Document Information			
Document #	0201741/02-RCA-0272	**Revision**	
Title	QUARTERLY NOTIFICATION OF CLASS 1 MODIFICATIONS TO THE HANFORD FACILITY RESOURCE CONSERVATION AND RECOVERY ACT (RCRA) PERMIT, DANGEROUS WASTE PORTION (QUARTER ENDING MARCH 31, 2002 - PERMIT CONDITION I.C.3)		
Date	04/09/2002		
Originator	J. HEBDON, R. H. GURSKE, R. D.(ROBY) ENGE	**Originator Co.**	DOE, FH, PNNL
Recipient	L. E. RUUD	**Recipient Co.**	DOEC
References			
Keywords			
Projects			
Other Information

APPENDIX 4B

DETAILED DRAWINGS FOR THE 200 AREA EFFLUENT TREATMENT FACILITY CONTAINER STORAGE AREA AND TANK SYSTEMS

ENGINEERING CHANGE NOTICE

FMP Section Title : SKT-1	Date: 10/18/01	H-2-89335-1, REV ~~15~~ 16

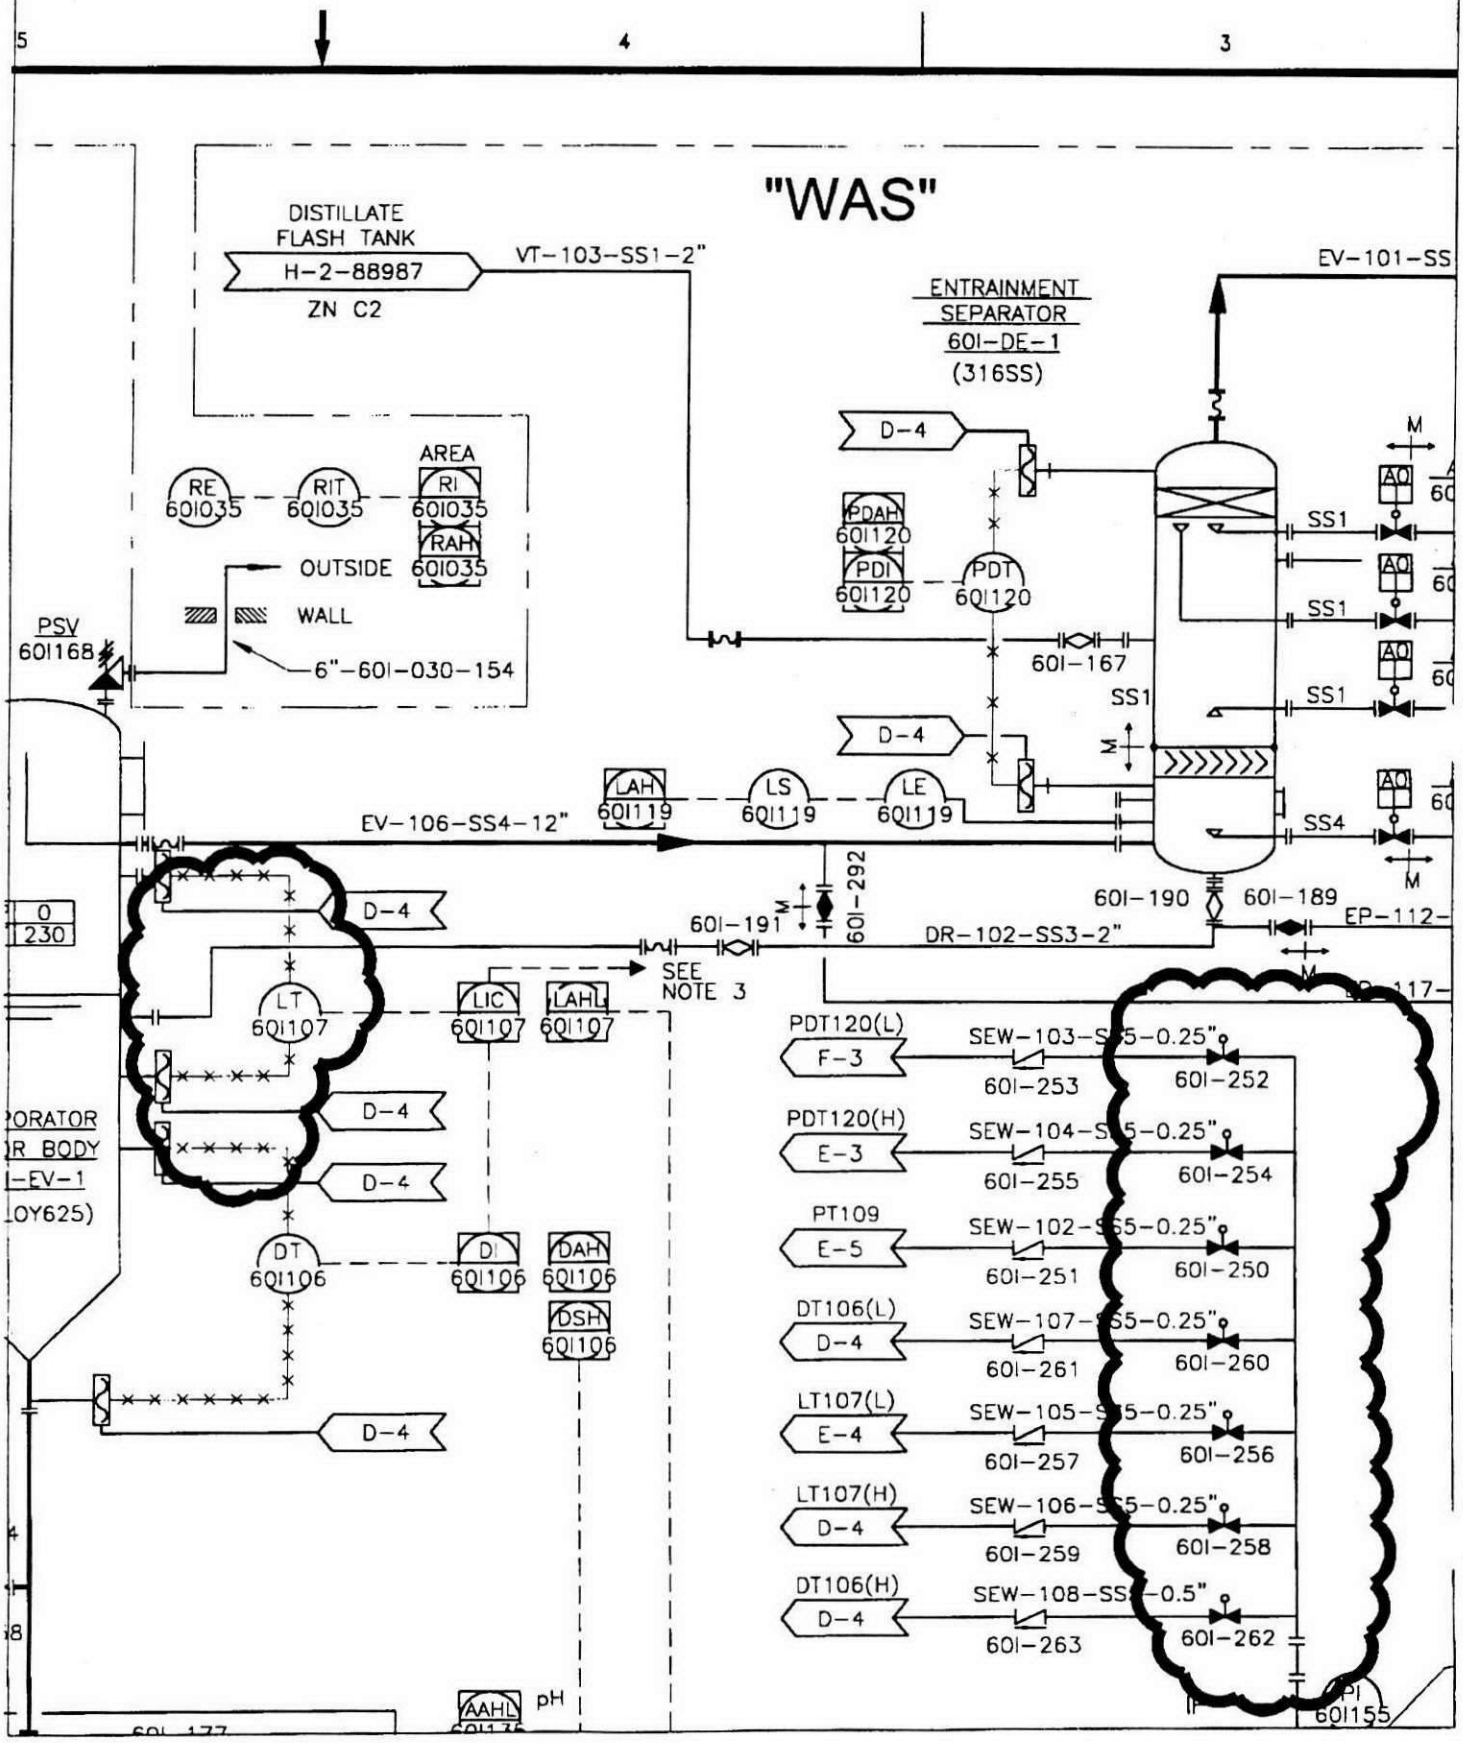
See sheet 3 thru 7 of this ECN for CONSTRUCTION DETAILS And sheets 8 and 9 of this ECN for changes to H-2-89335

Ref Dwg	Sh	Rev
H-2-88989	1	18/19

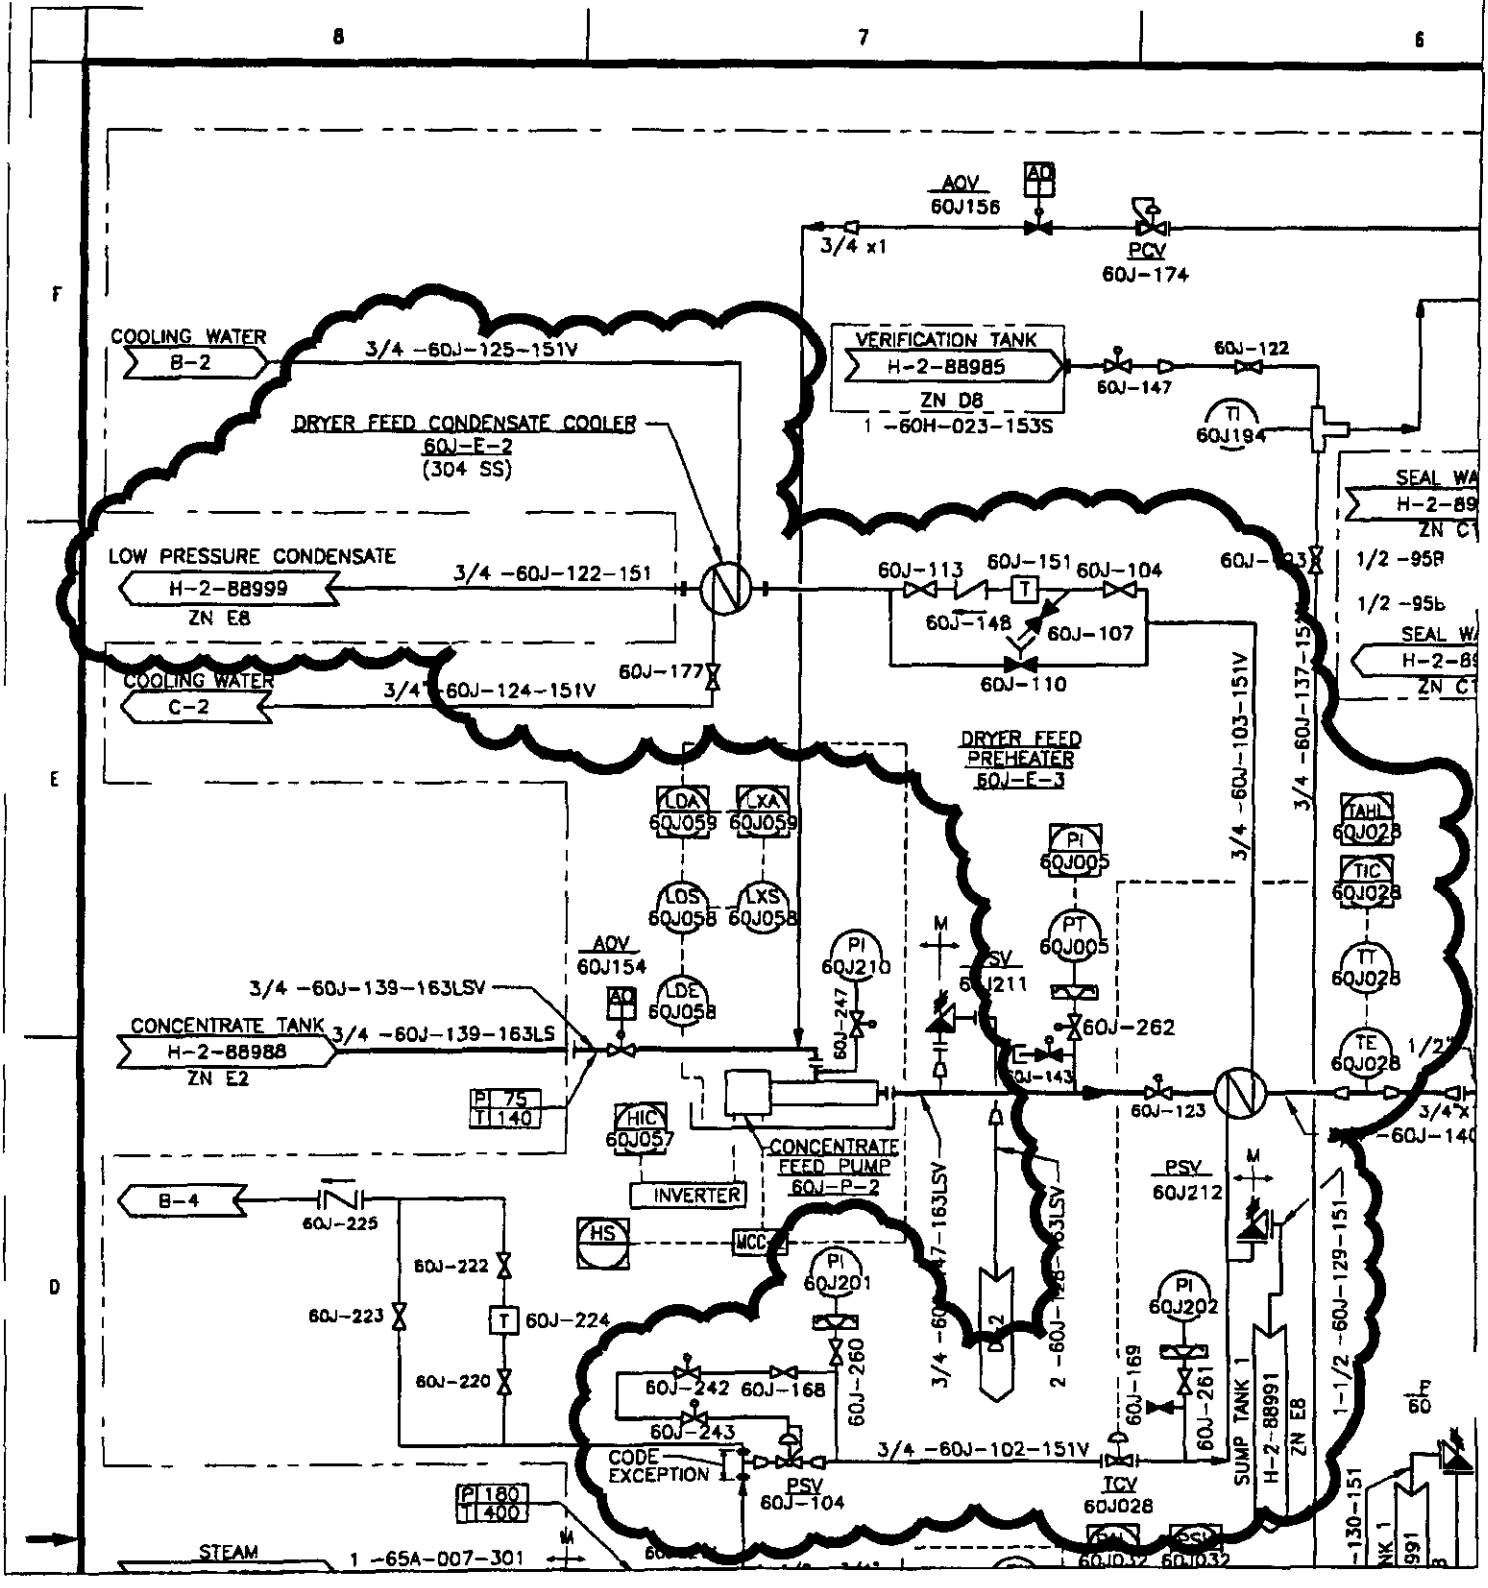
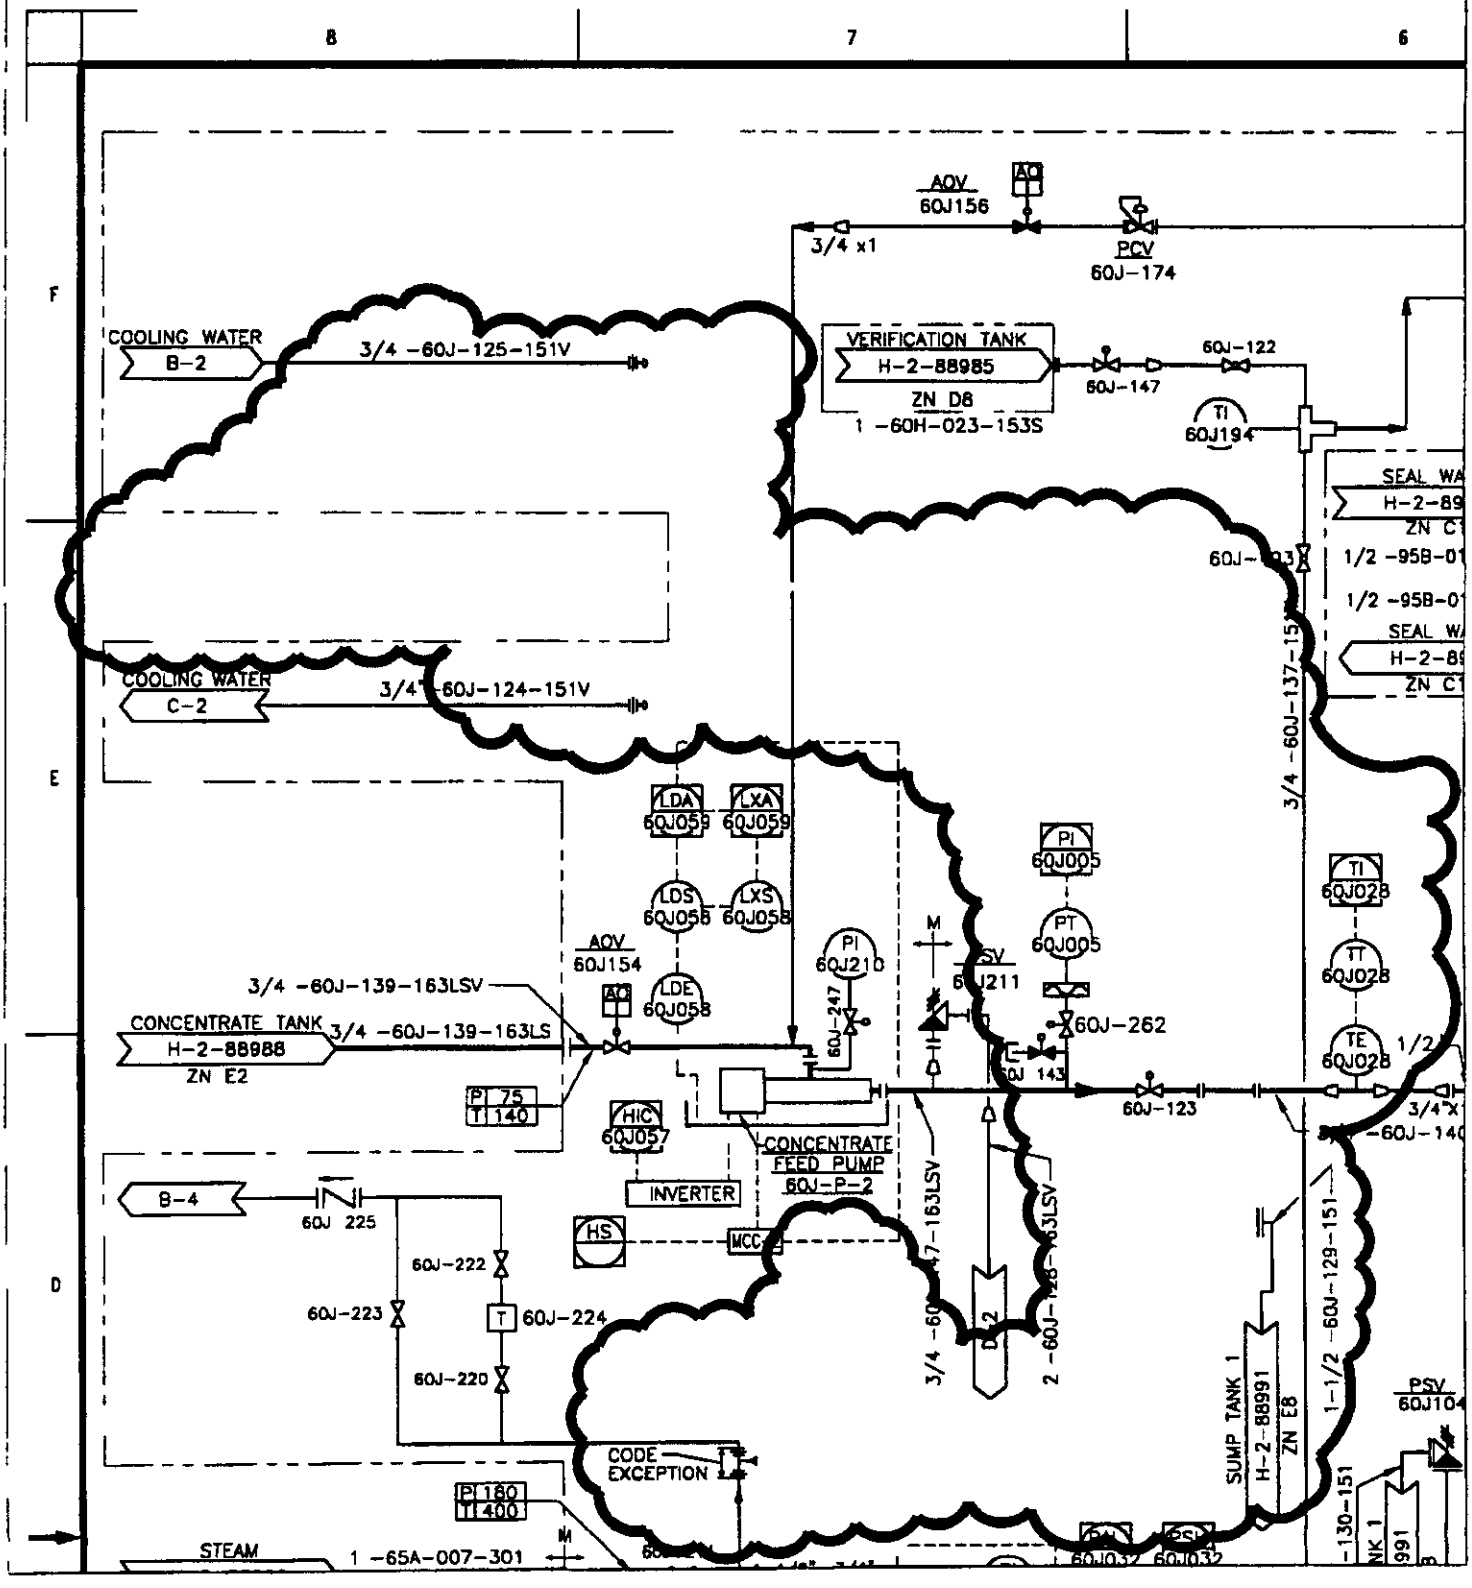
Changes to drawing H-2-88989 SHT 1 is shown on page 5 The following summarizes the changes made to this drawing

Ref Dwg	Sh	Rev
H-2-88999	1	~~13~~ 14

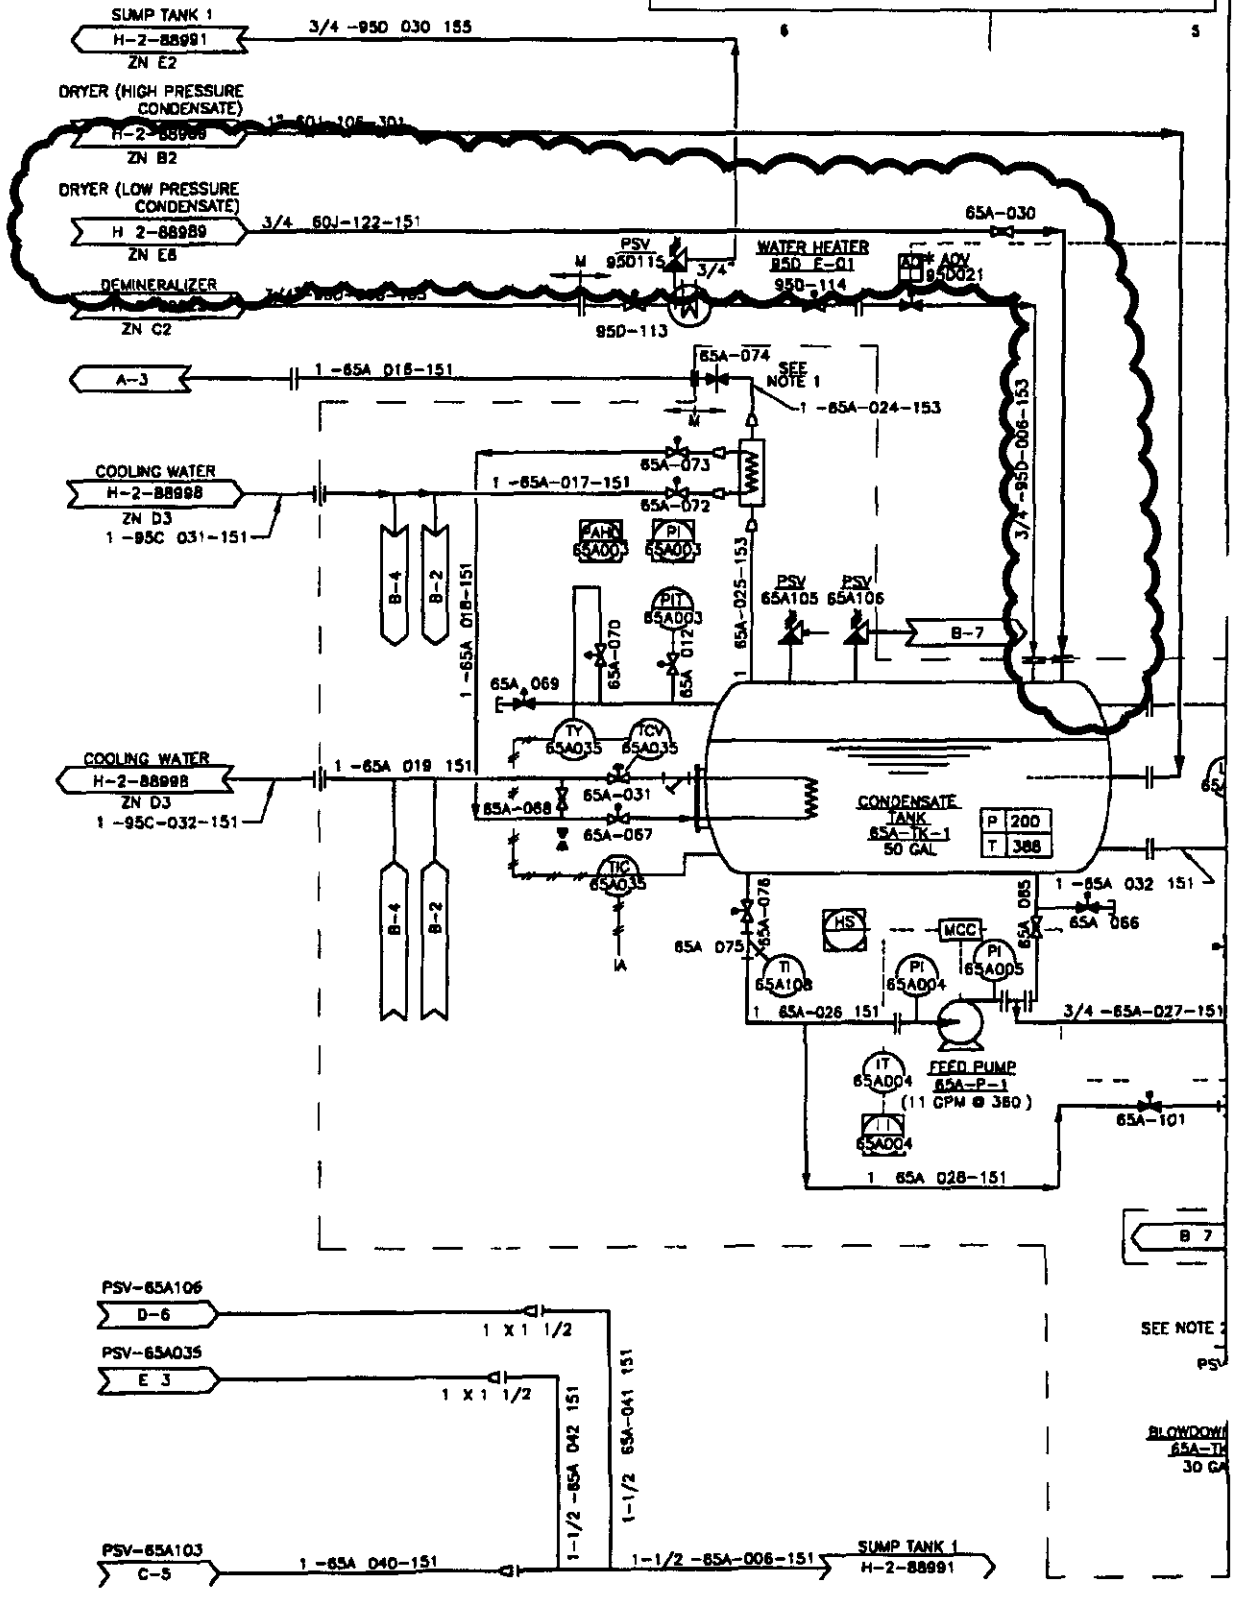
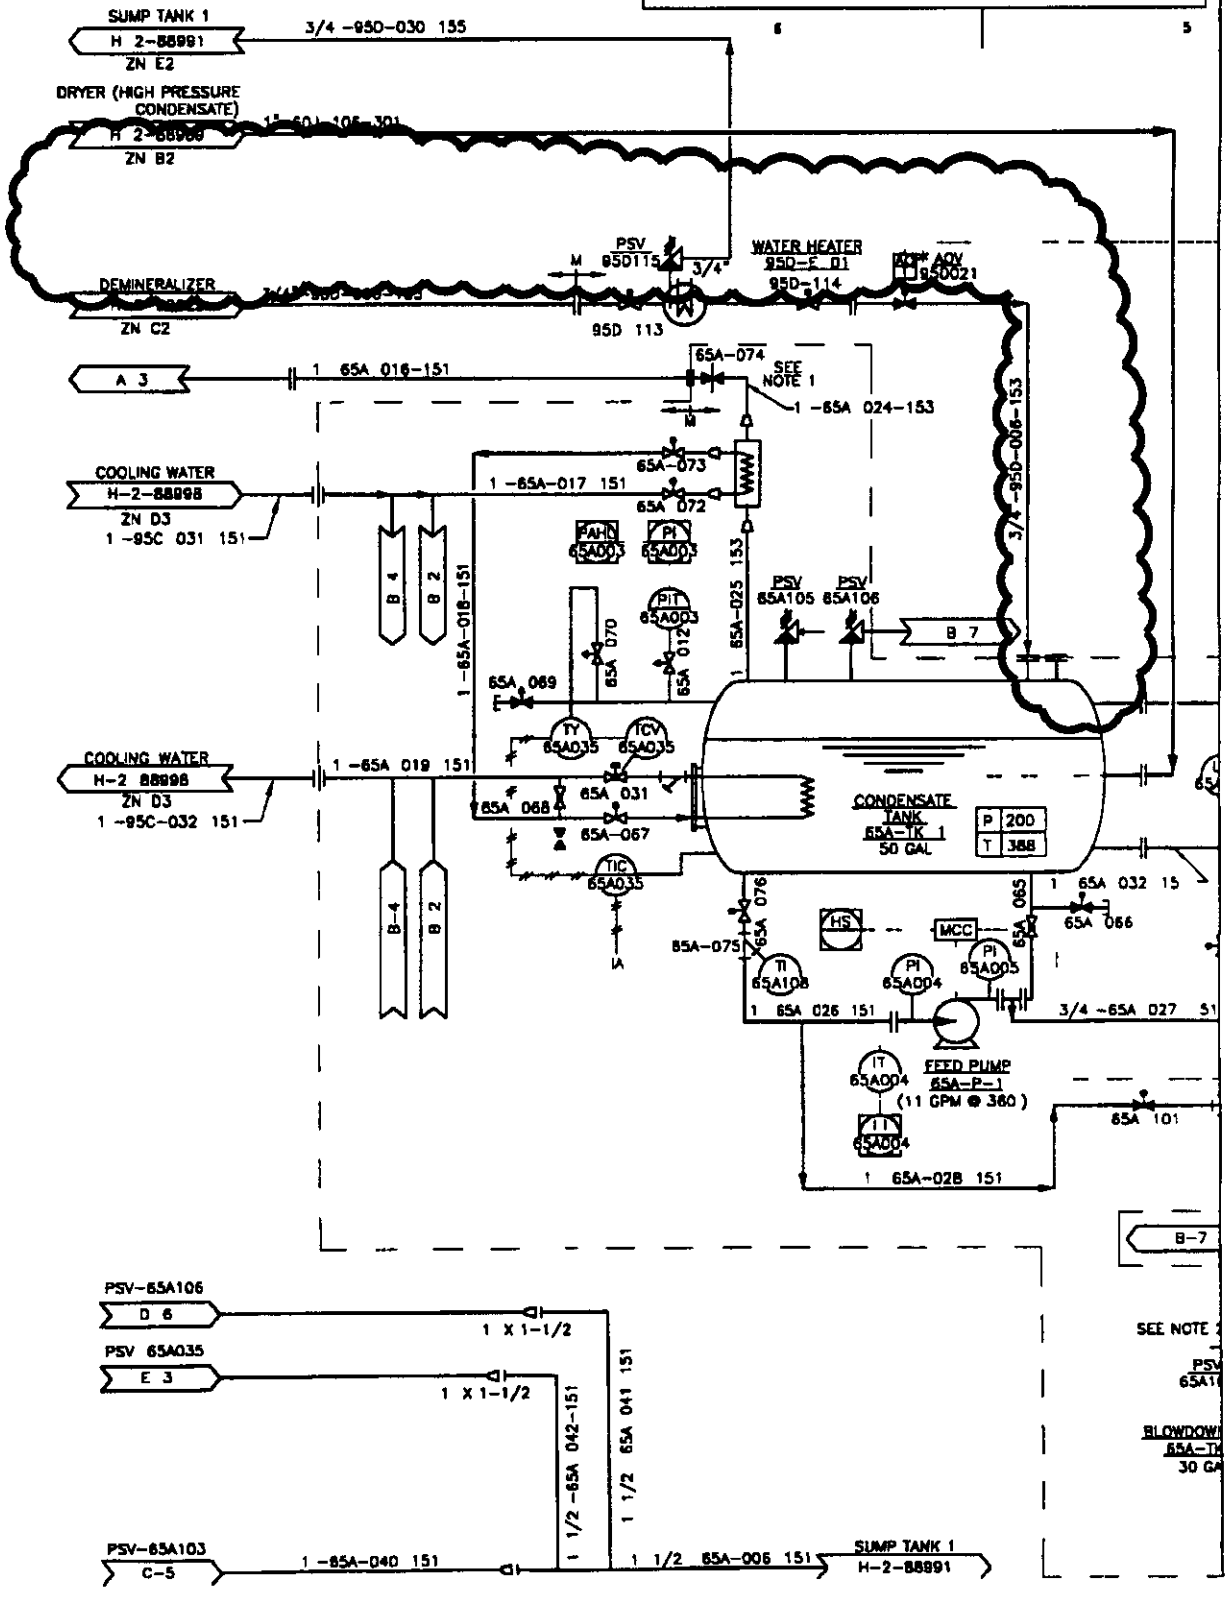
Changes to drawing H-2-88999 SHT 1 is shown on page 7 The following summarizes the changes made to this drawing
